VERMONT YANKEE NUCLEAR POWER CORPORATION

VERMONT YANKEE NUCLEAR POWER STATION

Amendment No. 75
License No. DPR-28

ATTACHMENT TO LICENSE AMENDMENT NO. 75

FIGURE 6.1.1
OFFSITE SUPPORT ORGANIZATION

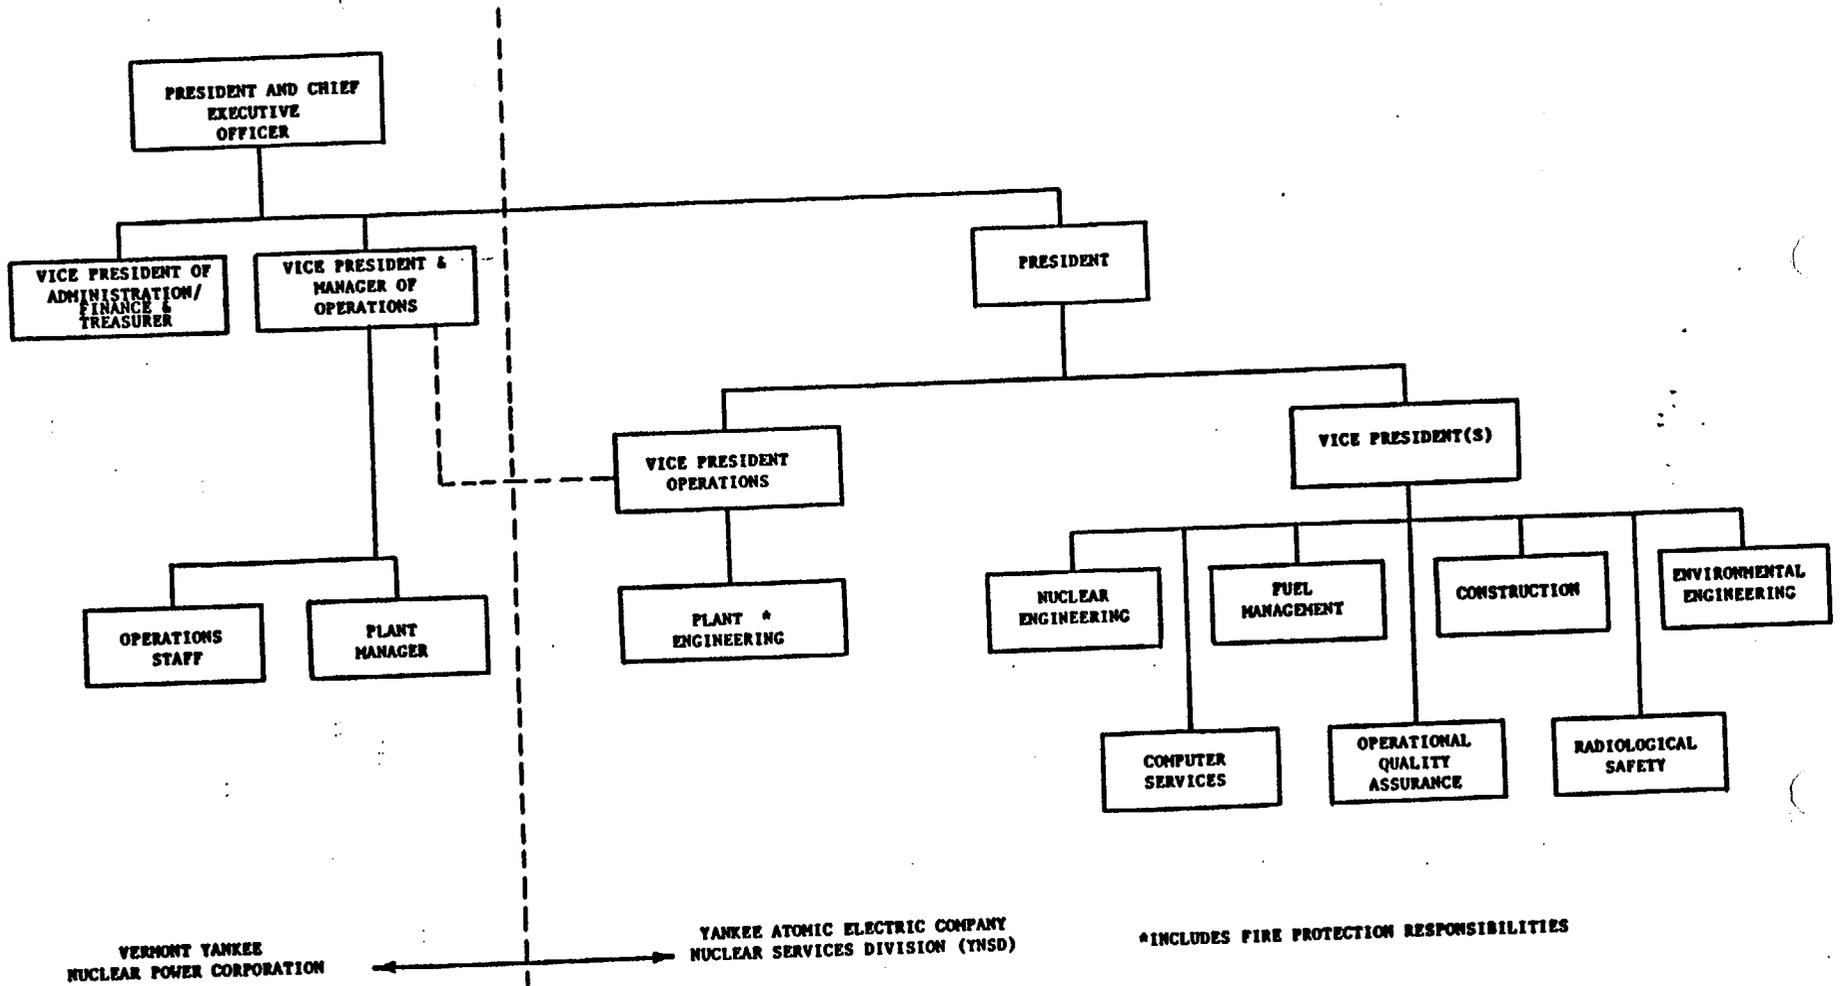
By letter dated September 27, 1982 the licensee proposed revision of the technical specifications describing the Vermont Yankee organization. Existing requirements are that the Plant Health Physicist shall meet or exceed the qualifications of Regulatory Guide 1.8, Revision 1, Personnel Selection and Training. The proposed technical specifications would permit the Chemistry and Health Physics Supervisor or the Plant Health Physicist to meet this requirement. Because the Plant Health Physicist reports to the Chemistry and Health Physics Supervisor, the proposed technical specification would preserve the lines of reporting responsibility, previously approved, and is acceptable.

In addition the September 27, 1982 proposed revision of the technical specifications describes changes in job titles and groupings of non operational work functions which are purely administrative. These changes are acceptable.

ORGANIZATIONAL CHART
FIGURE 6.1.2

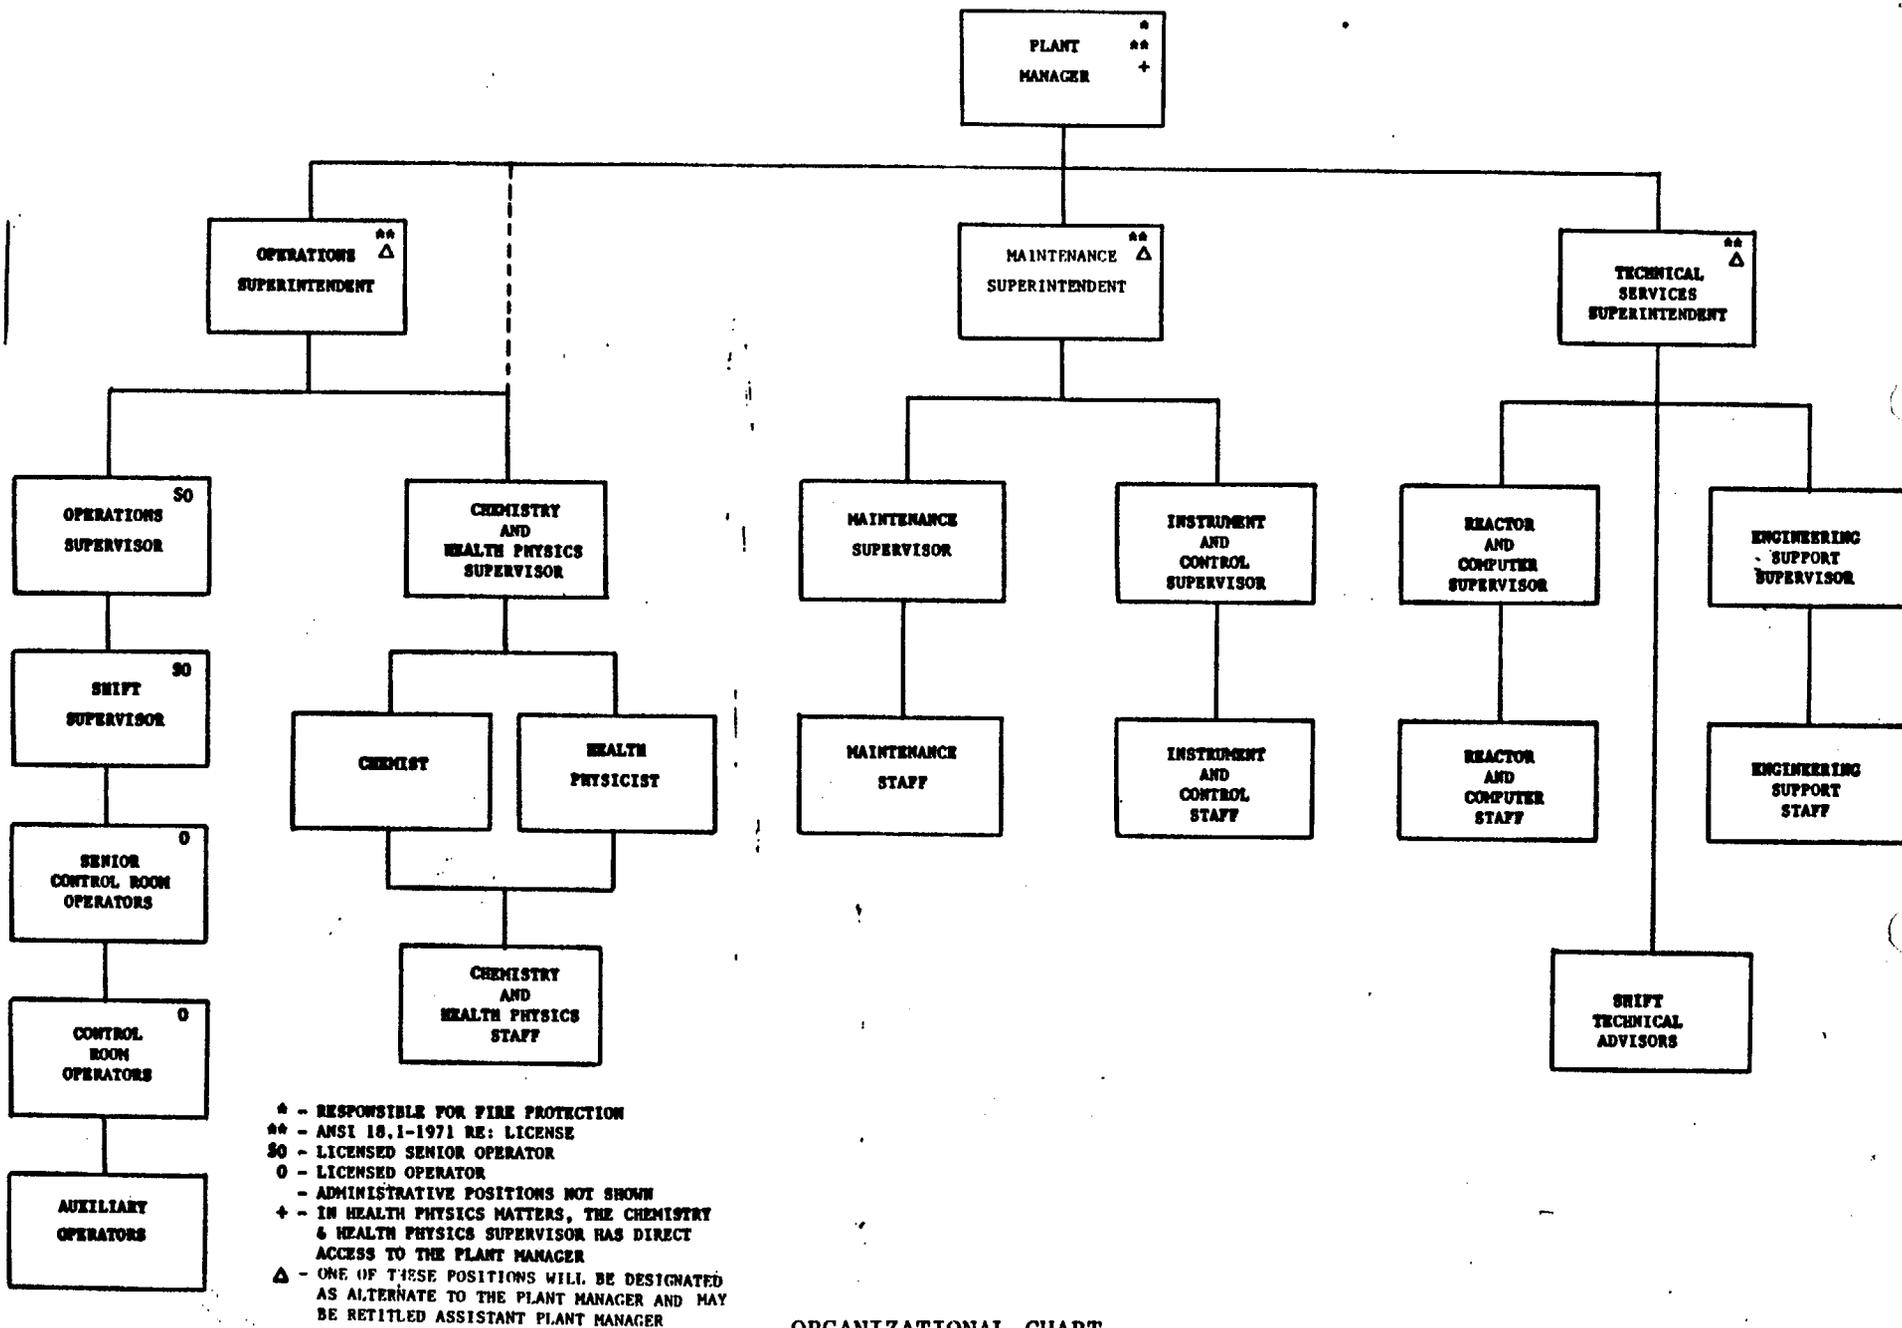
The licensee proposed a further revision to the organizational technical specifications by letter dated December 7, 1982. The position title of the Assistant Plant Manager was changed to Maintenance Superintendent. Also, it was proposed that any of the three superintendents reporting directly to the Plant Manager could have on-site responsibility for safe and efficient operation of the facility during the absence of the Plant Manager, providing the responsibility was delegated in writing. Because each of the three superintendents must meet the requirements of ANSI 1811-1971 with respect to qualifications, this change is considered acceptable.
